TECHNICAL INFORMATION RECALL ACTION

MODEL		SUBJECT		01/12/96
Discovery - All derivatives		Front Right Hand Door Latch Loads - Inconsistent		A/B/D 456
Discovery - All derivatives		AFFECTED VEHICLES		
Discovery - All derivatives		LJ	156137 to 200000	
		LJ	500032 to 537985	
		LJ	700000 to 707210

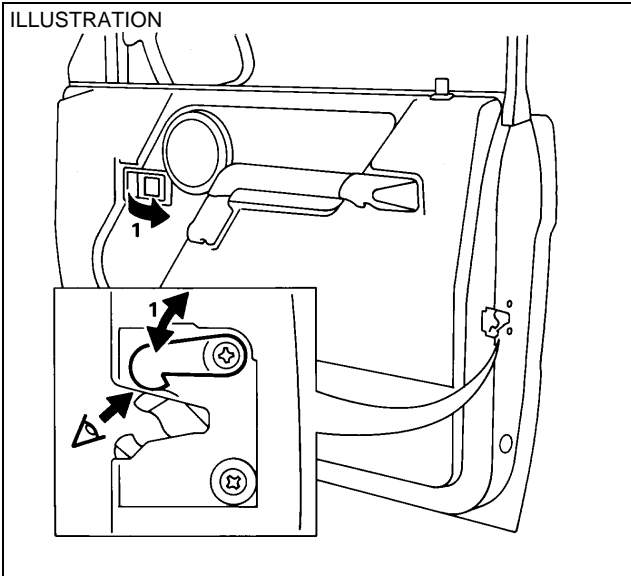
To overcome inconsistent front right hand door latch operating loads which could be identified as 'bounce' when the door is closed and to prevent any further customer annoyance Land Rover are implementing a campaign to check the operation of the door latch. The result of this check will introduce a new extended length screw fitted to the upper exterior latch fixing, and in extreme cases the fitment of a new latch. Investigations by Land Rover Engineers have found that due to a tolerance build up during vehicle manufacture the outer frame leg may contact the upper corner of the latch in the interior of the door. The fitment of the extended length screw eliminates this contact and reduces the latch operating load. The procedure below should be followed carefully to determine the level of fix applied to a vehicle that exhibits this concern.

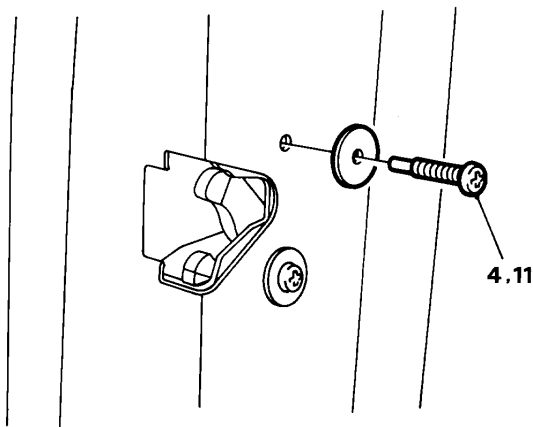
4. If no restriction is felt and the pawl moves freely in the latch fit **new** screw STC 3763 and washer AFU 1069 to the upper latch fixing on the door shut face, tighten to 4 Nm.

5. If during the check it is found that resistance is felt, again with the door unlocked, open the door very slowly with the exterior release handle and release the handle slowly to its rest position then close the door. Repeat this operation six times and check that the door does not bounce open clear of the striker on the 'B' post.
6. If the door exhibits a 'bounce condition' this is evidence of a latch load that is inconsistent and the latch will require replacement.

Latch Replacement

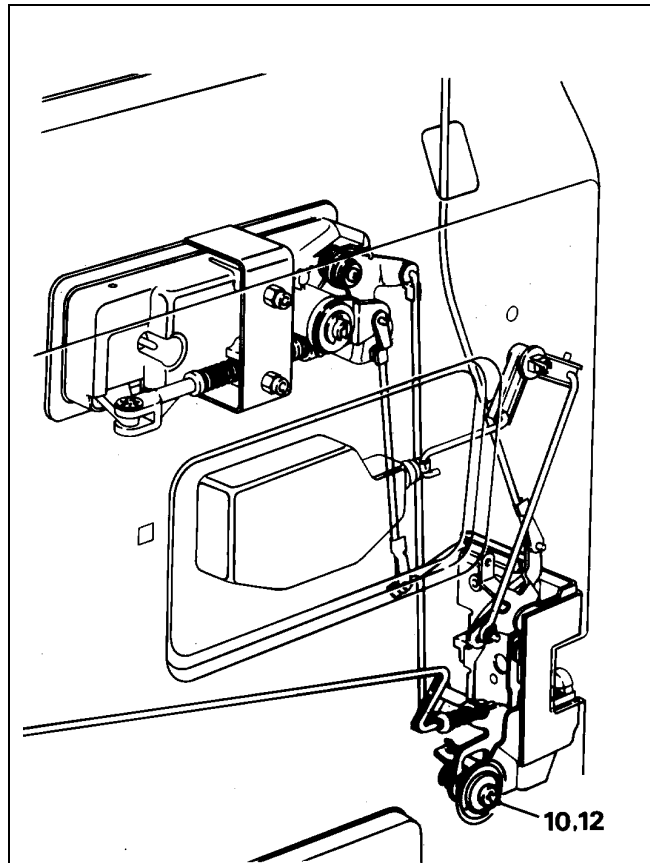
7. Carefully remove door trim pad.
8. Carefully lift water curtain to avoid damage in areas that will provide access to the interior of the door.
9. Remove glass frame and latch. Discard latch.
Note: In markets where there is no return procedure for warranty parts, displaced latches should be rendered inoperative but retained for 3 months for inspection.
10. Prior to fitting a new latch open out the latch fixing hole in the door panel to 12 mm diameter. Remove any sharp edges from around the hole.

11. Fit a new latch, Part number MTC 7593 and gasket MUC 1822 to the door panel. The new extended length screw STC 3763 and washer AFU 1069 **MUST** be fitted to the upper latch fixing on the shut face of the door.
12. Prior to securing the latch to the inner door panel a new washer AFU 1069 must be used under the hexagon head screw.
13. Rebuild the door as described in section 76 of the workshop manual noting the following care points.
- When resetting the latch, check the setting of the central door locking actuator plate. This is critical to the sill button operation and the functional setting of the latch.
 - After the replacement of the glass frame and prior to refitting the door trim pad check the alignment of the glass frame to door aperture to ensure no water leaks or wind noise is evident.

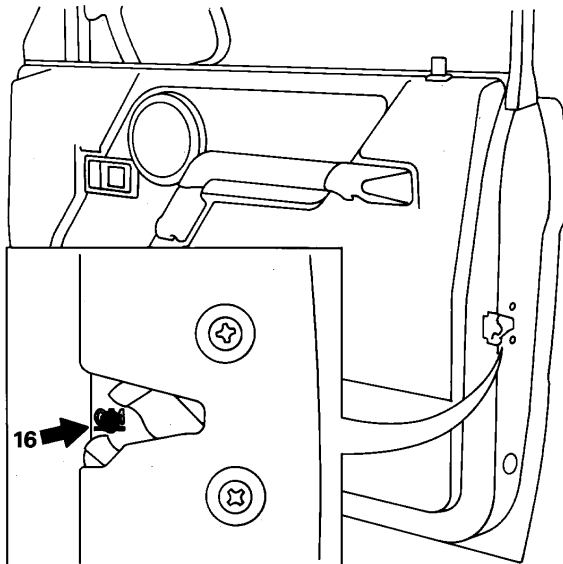
14. Repeat the detail checks of the door latch operation to ensure that it is fully functional.
15. Carefully refit the water curtain ensuring that no gaps are evident that will permit water ingress.
16. **IMPORTANT:** Apply a small amount of yellow paint to the latch throat, (refer to illustration) on the shut face of the door to prevent this fix being completed unnecessarily by another dealer.
